**Economic Commission for Europe****Inland Transport Committee****World Forum for Harmonization of Vehicle Regulations****Working Party on Noise****Sixty-eighth session**

Geneva, 12–14 September 2018

**UN Regulation No. 51 (Noise of M and N categories of vehicles):****Development****Proposal for Supplement 5 to the 03 series of amendments to  
UN Regulation No. 51 (Noise of M and N categories of  
vehicles)****Submitted by the Informal Working Group on Additional Sound  
Emission Provisions\***

“Figure 3c

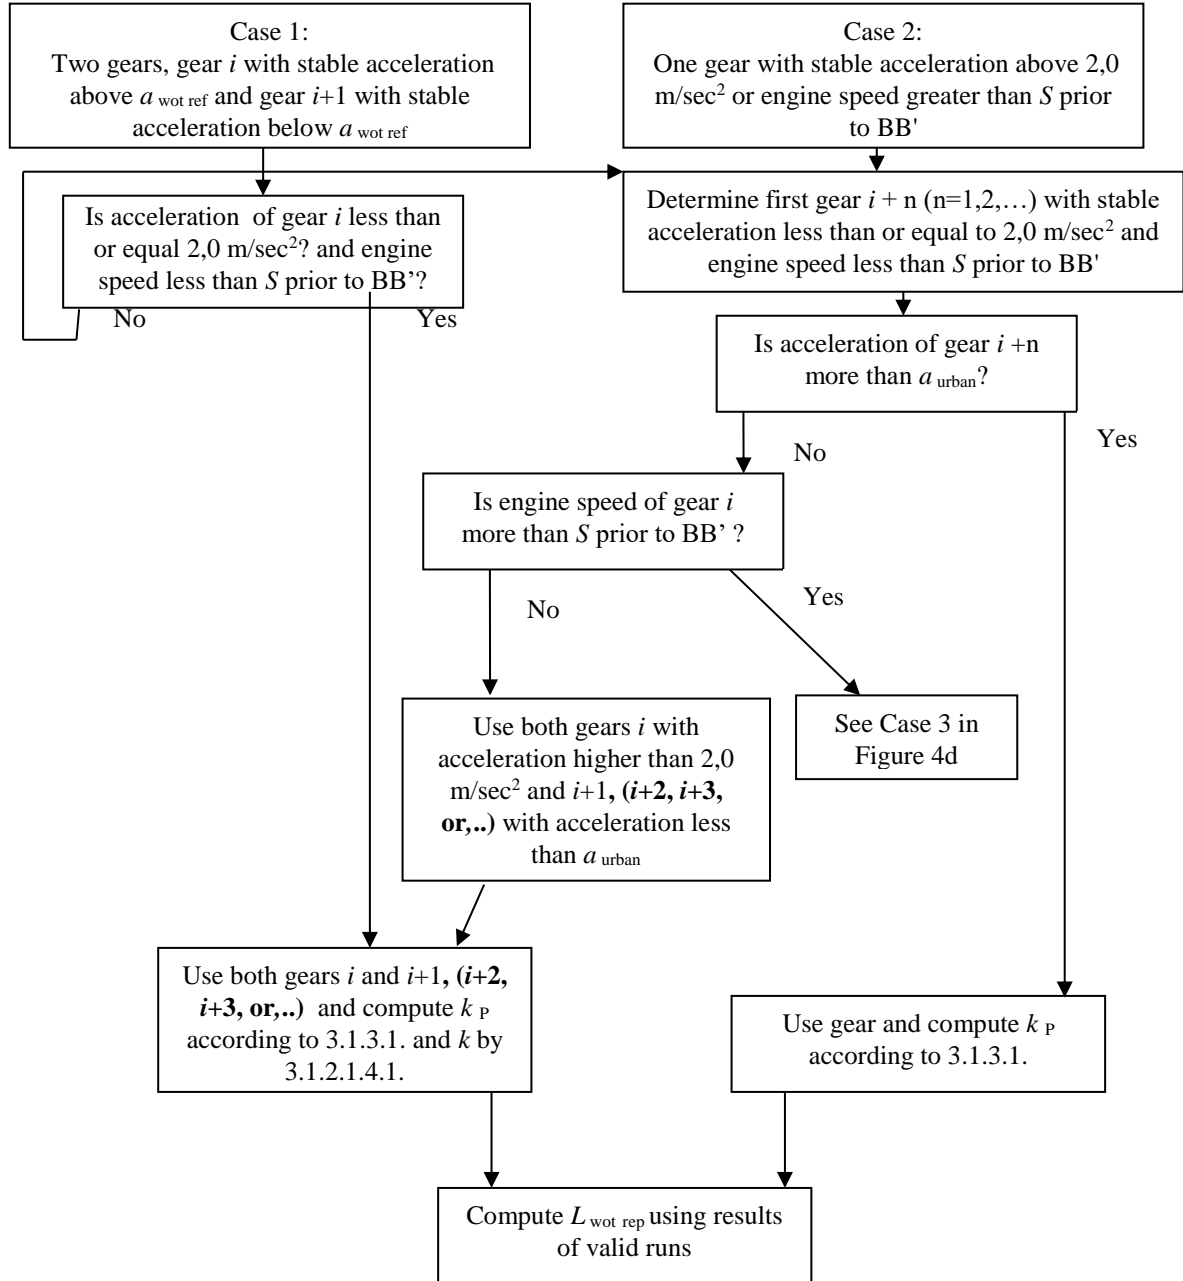
Appendix to Annex 3, Figure 3c, amend to read:

– Gear selection using locked gear PART 2”

1. The proposed change aligns the flowchart with the amendment to paragraph 3.1.2.1.4.1 (c) of Supplement 3 to the 03 series of amendments to UN Regulation No. 51.
